REGIONAL REVIEW NOTICE

ARC REVIEW CODE: R1509221

Name of Proposal: Jodeco Crossings

Conceptual Master Plan - DRI# 2504
Jodeco Crossings
Land Lots 77,78 & 83 / District 6 / Henry County, Georgia
Prepared for:
**Estate of Guey L. Chen &
The Marital Trust / Trustee Yee Chen**
Henry County, Georgia

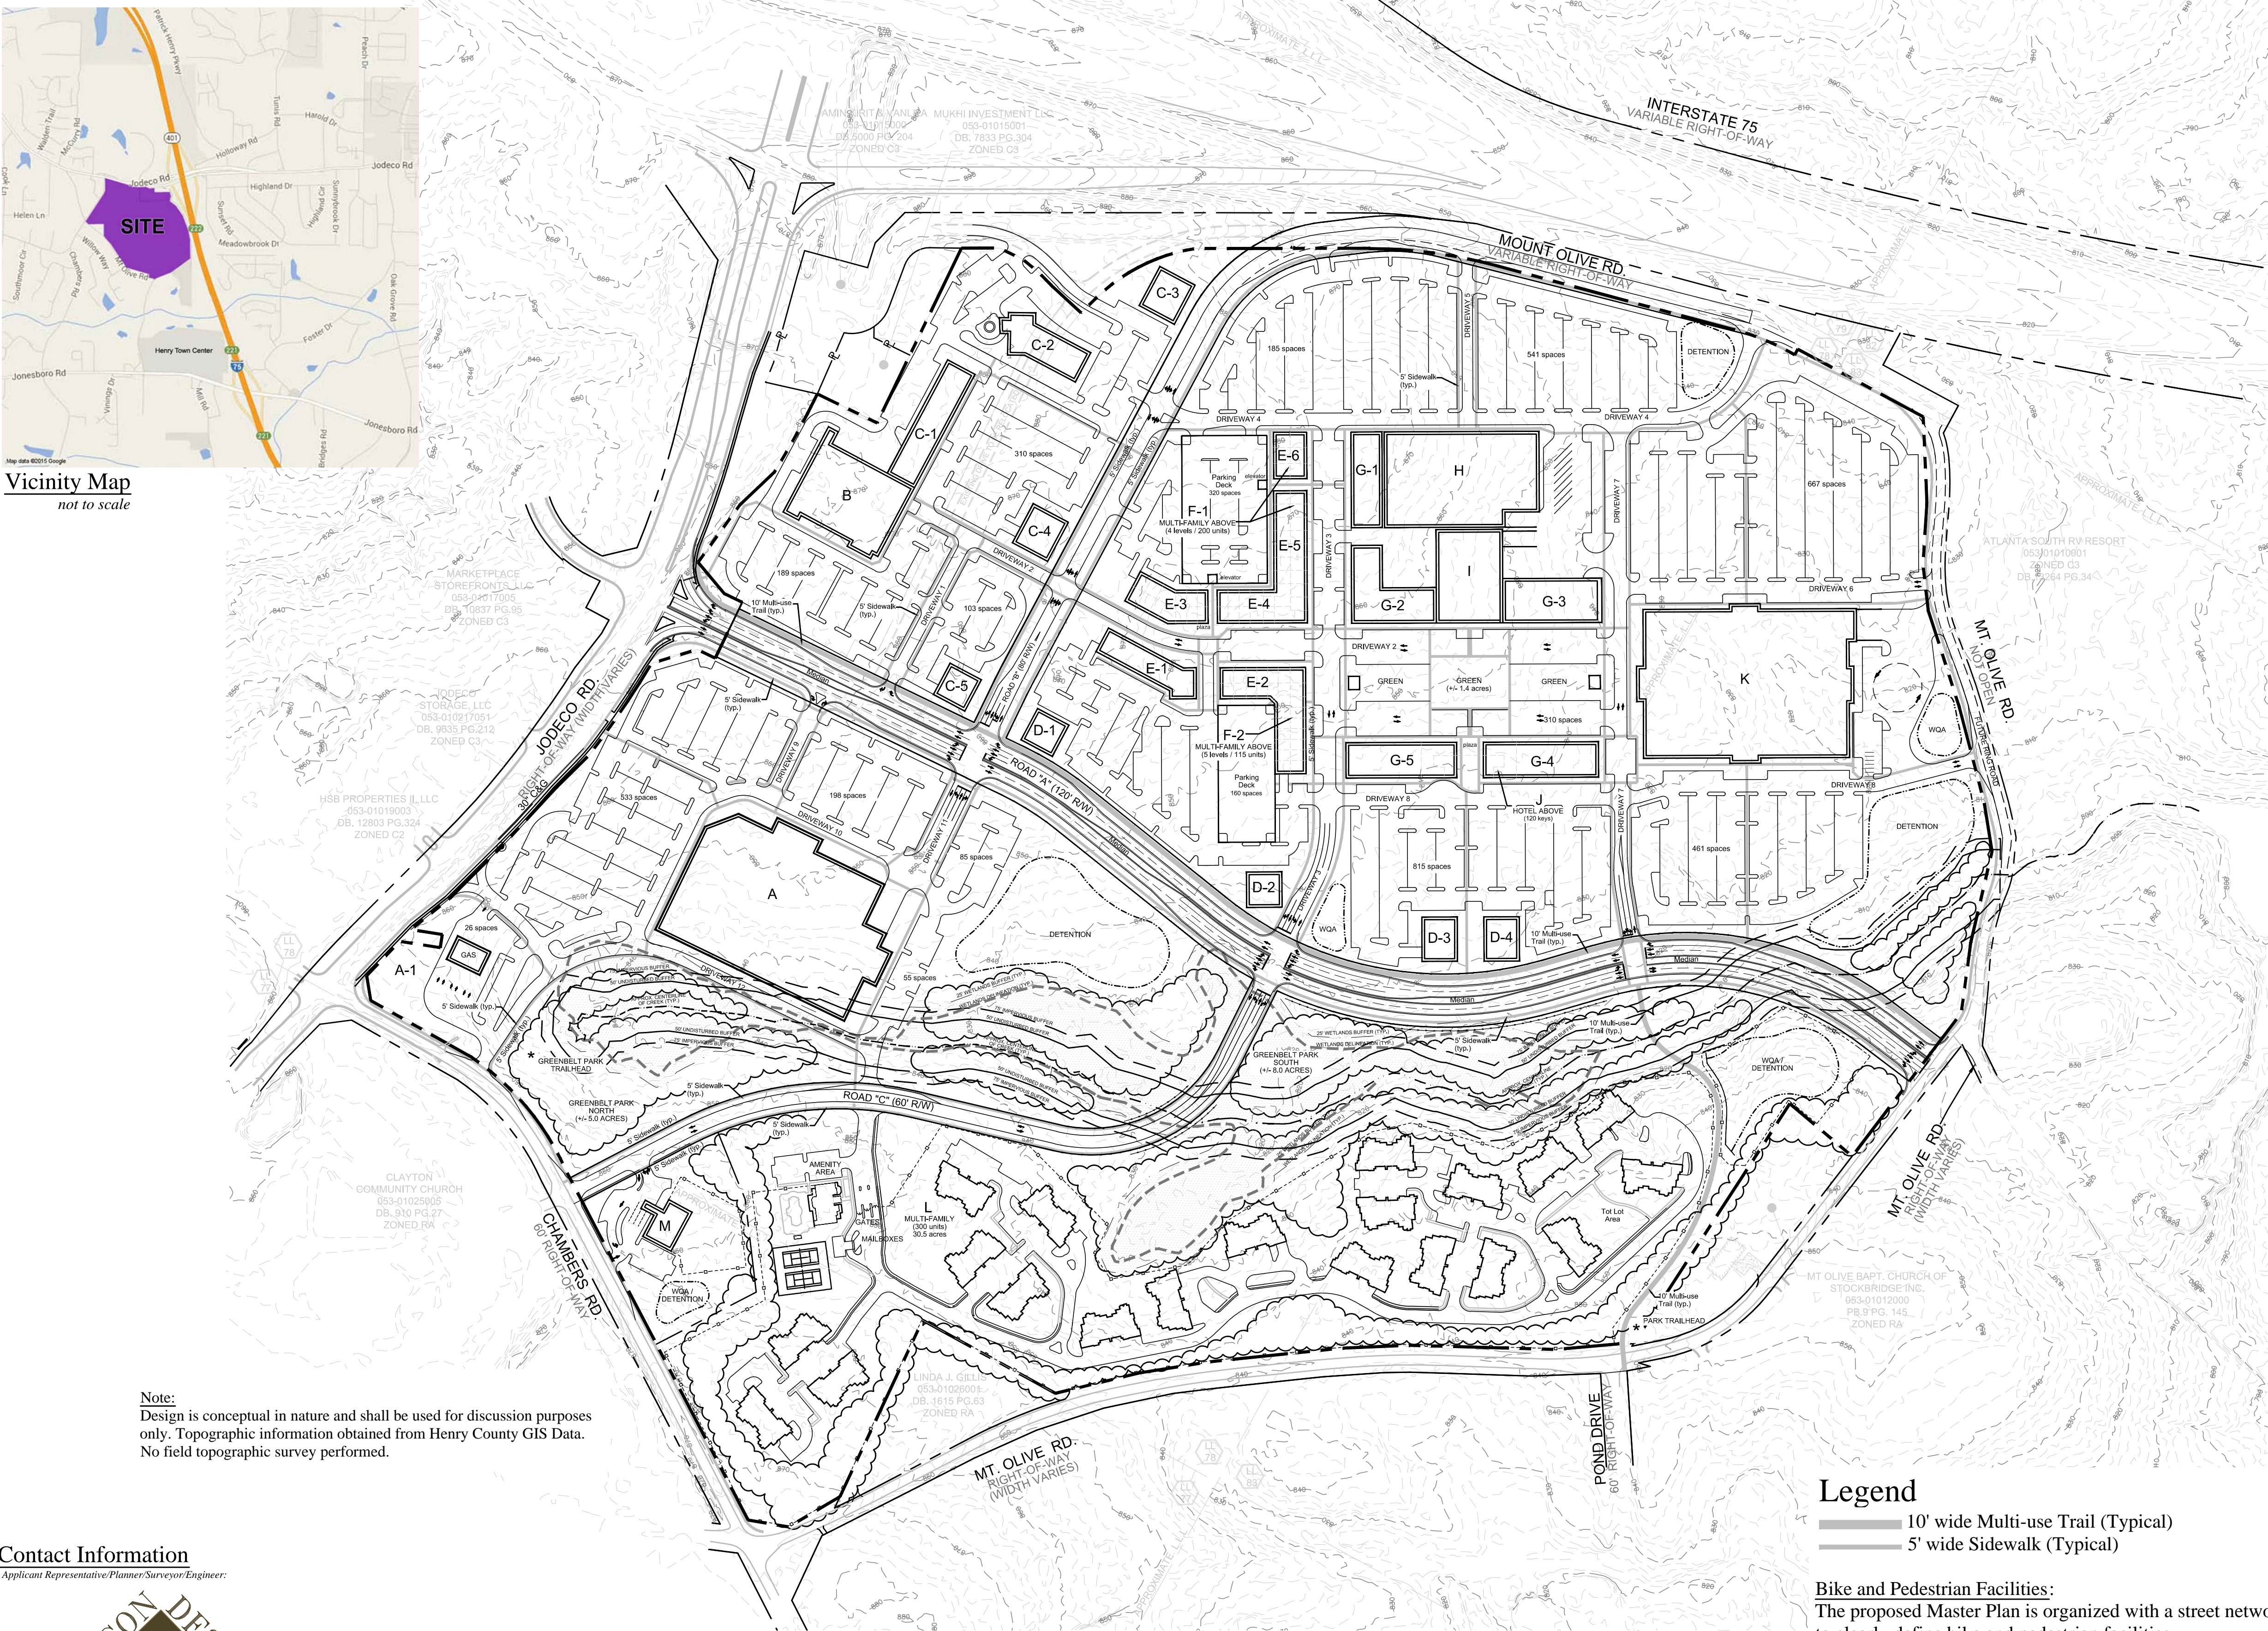
Additionally, the 300-unit multi-family complex (Building(s) L on the site plan) on the west and southwest sides of the site is separated from the core of the site by a creek and wetlands, two roadways (60' and 120' rights-of-way), and several hundred feet of distance. The complex is also fenced on all sides, with one gated access point. Care should be taken to better connect this area with the rest of the site so that residents have the option to access others uses (e.g., neighborhood-serving retail, grocery, restaurants, etc.) via walking or bicycle trips.

Where parking garages are proposed, they should be screened from view to minimize visual impact, for example along the "open" sides of the proposed garages behind Buildings E-2 and E-3/4/5/6 on the site plan. The current plan proposes a large surface parking lot, west and northwest of Building A on the site plan, that fronts on a lengthy section of Jodeco Road. The developer and Henry County should explore strategies for minimizing the visual impact of this surface parking on the surrounding community.

See additional staff comments included in this report. Note the ARC Natural Resources Division staff comments highlighting the need for the developer to ensure compliance with all applicable requirements related to water supply watersheds as well as stream and wetland buffers (with particular respect to the siting of Road A, Road C and Building A on the site plan, in relation to buffers).

A stream is shown on the property, running roughly north-south and dividing the multi-family section from the commercial section. A 50-foot undisturbed buffer and 75-foot impervious surface setback are shown along the stream, which conform to the requirements of Henry County's Stream Buffer Ordinance. However, the proposed specialty retail superstore site identified as Building A on submitted Plans, along with portions of Roads A and C intrude on those buffers. Any intrusion into the buffers may require a variance from Henry County.
